Plan: 1003

CHECK LIST FOR SEPTIC PLANS

**RE: S. Tank, P. Chamber And L. field (Repair)  
Installation Inspection  
# 45 Leverett Road (Crossman)**

**SEPTIC SYSTEM REPAIR PLAN FOR TOM CROSSMAN**  
**45 LEVERETT ROAD**  
**AMHERST, MA**

AS BUILT  
05.28.2010  
MAP 3c LOT 48  
SCALE: 1"=30'  
17,900± SF.

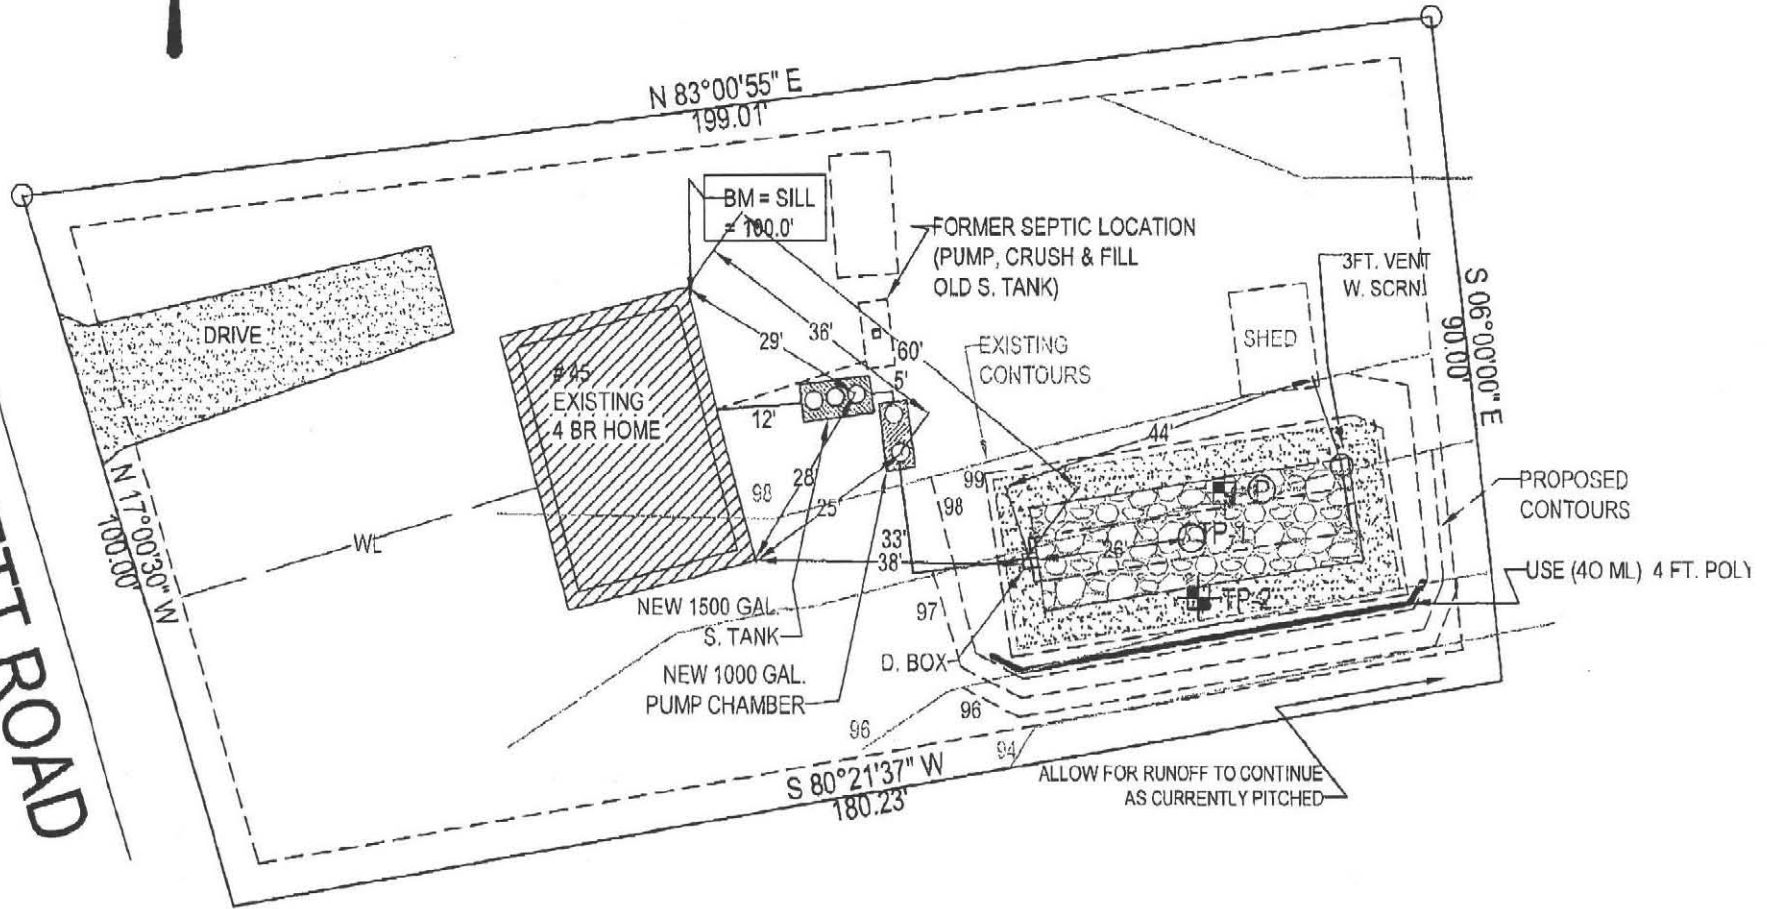
On this date, the writer inspected the installation of a **(Septic System)**. The writer found the installation to be complete (except for completion of cover material) and in compliance with our plans and 310 CMR 15.000. The installer representative **(Gary Gilmore Excavation)** and our inspection noted that the system was built & installed properly, in accordance with the state/local regulations and our plans. The contractor was requested to have sufficient soil on site and properly cover the system according to our plans and may backfill the system after review by local Health Department representatives.
